RE: DRAINAGE PLAN FOR AIRLINE PROVISIONING BUILDING
(M-15/D25) RECEIVED SEPTEMBER 18, 1987

Re: Aircraft Provisioning Building
Albuquerque International Airport
Storm Drainage Plan Changes
City Reference Number: M-15/D25
Architect's Project Number: 8666

Re: Drainage Plan for Airline Provisioning Building
(M-15/D25) Sent January 29, 1987
Architect's Project Number: 8666

RE: DRAINAGE PLAN FOR AIRLINE PROVISIONING BUILDING
(M-15/D25) RECEIVED JANUARY 29, 1987

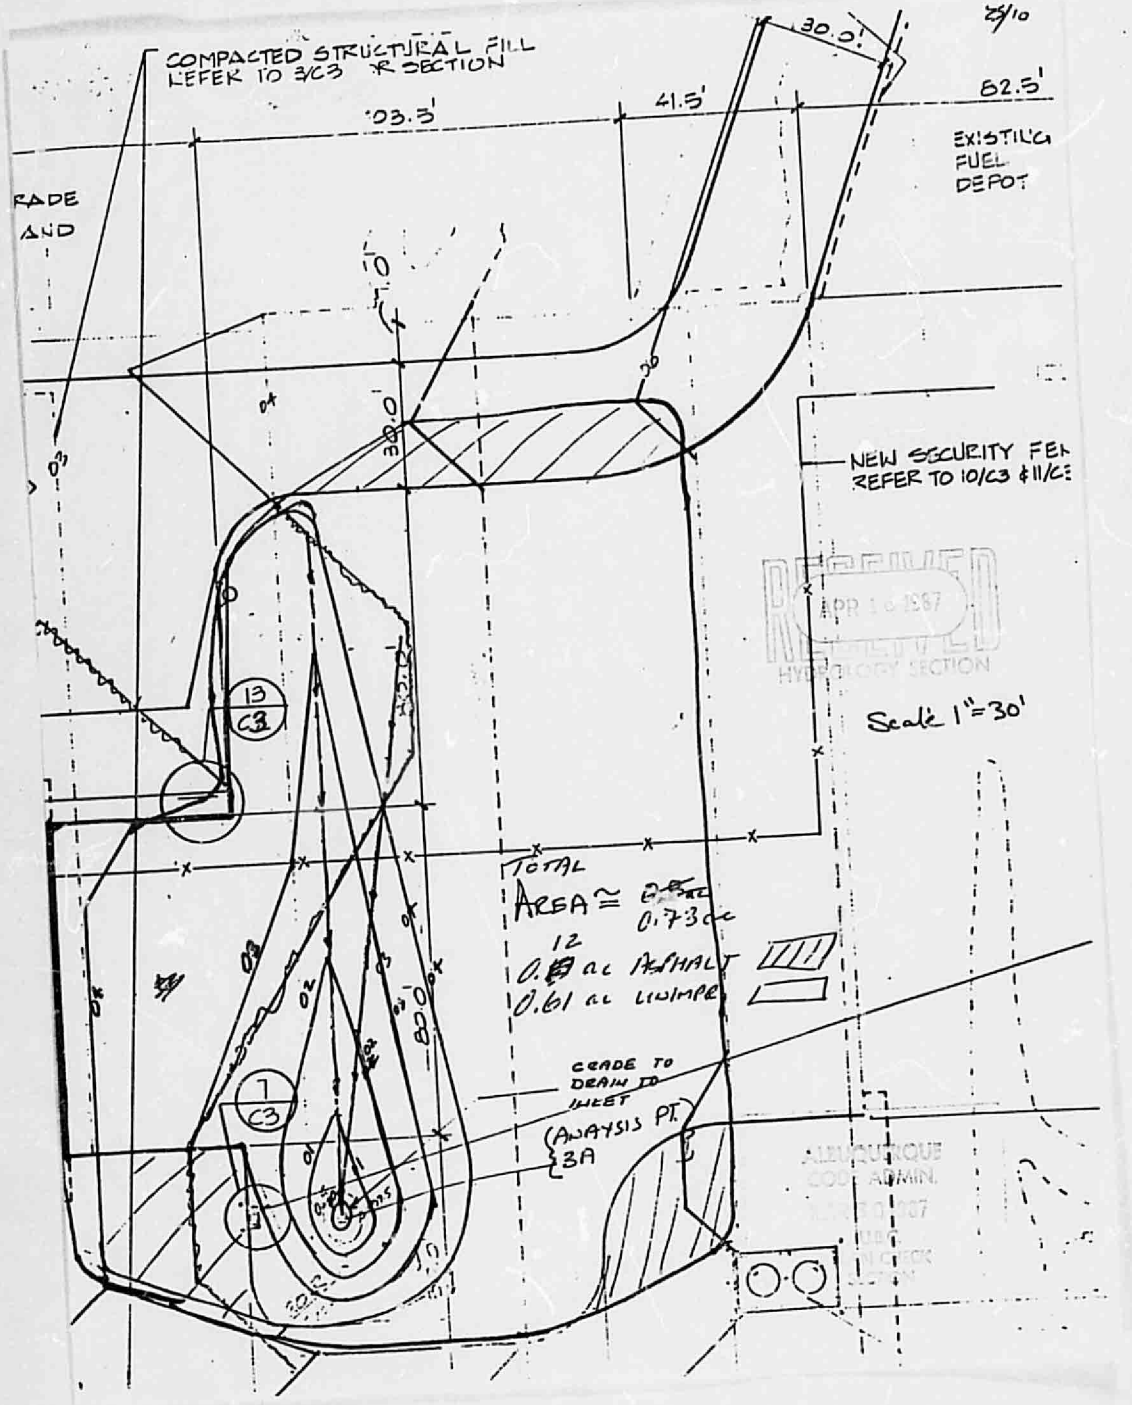
TOTAL AREA = 0.73 ac
UNIMPROVED AREA (DIRT) = 0.61 ac C = 0.40
ASPHALT AREA = 0.12 ac C = 0.95

$$C = \frac{(0.61)(0.40) + (0.12)(0.95)}{0.73} = 0.49 \text{ (WEIGHTED AVG.)}$$

$$Q_{100} = CiA = (0.49)(4.86)(0.73) = \underline{1.7 \text{ CFS}}$$
